PJM Potential Load Forecast Changes

Questions, Concerns and Comments

Public Service Electric & Gas

August 15, 2019

PJM, "Potential Load Forecast Changes", P. 13

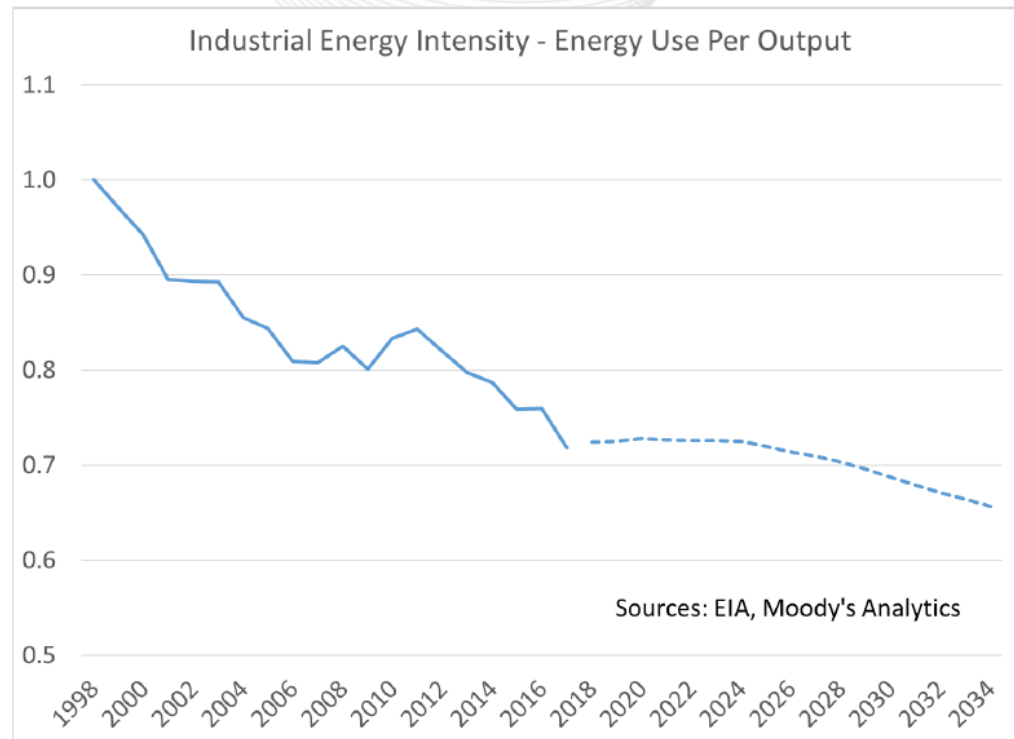
- What is the "Working Age Population" in the Commercial drivers supposed to represent? It doesn't seem to be a good measure of commercial employment/activity or of the demand for commercial services. Income-based and population-based measures seem to be better drivers of the demand for commercial services.
- I'm a little confused by the Industrial specification. It appears to be a tautology where:
$$\text{Energy} = f(\text{Goods-Producing Output, electricity Used Per Output}) = \text{Energy}$$

I think that I need some clarification of what you're trying to do here.

PJM, "Potential Load Forecast Changes", P. 20

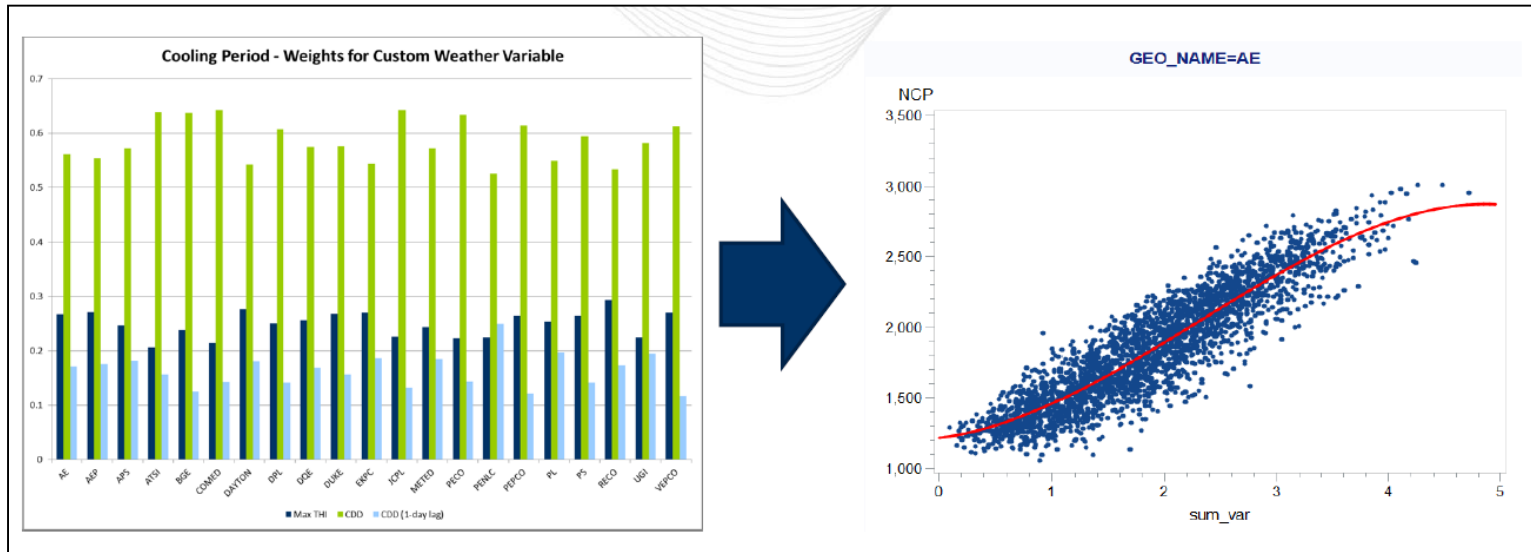
- Why are you using both CDD and THI? The general consensus is that cooling load is a function of temperature and humidity so what's the justification of using CDD, a temperature-based measure?
- Has it been verified that the max daily THI never occurs AFTER the peak?
- What is the basis for the variables that are used in the winter weather variable calculation. Has it been verified that the Minimum Daily WWP never occurs AFTER the peak?
- Why is the average daily WWP variable in the specification when its value may have been significantly influenced by weather that occurred AFTER the peak?

PJM, "Potential Load Forecast Changes", P. 27

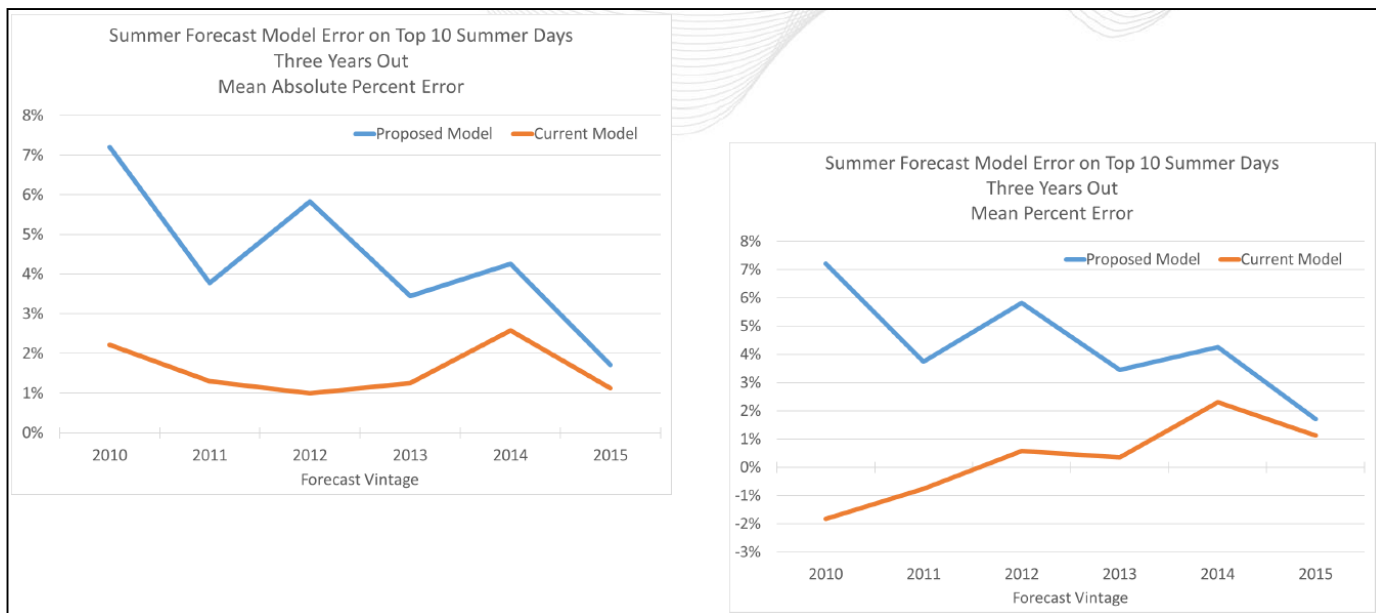
- Using average daily NEM capacity factors will, most likely, still understate the impact of solar since the peak hour will be a time of higher than average load and higher than average solar generation.
- Perhaps trying to generate the relationship between load and solar output could be placed on the list of future model enhancements to enable a better matching of solar capacity to hourly loads.

PJM, "Potential Load Forecast Changes", P. 35

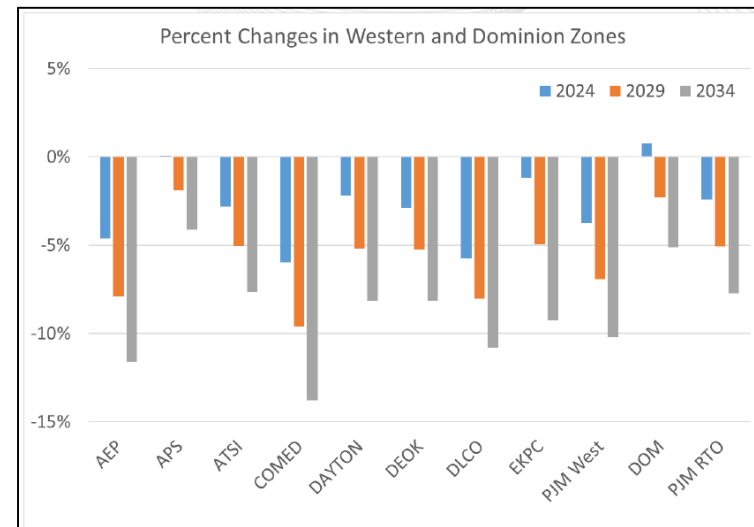
- The change in the RTO forecast is consistent with a model whose errors are becoming increasingly negative over time.
- If it is assumed that it is better to overestimate capacity requirements than underestimate capacity requirements, given the lead times for construction, adopting the proposed model seems very risky.
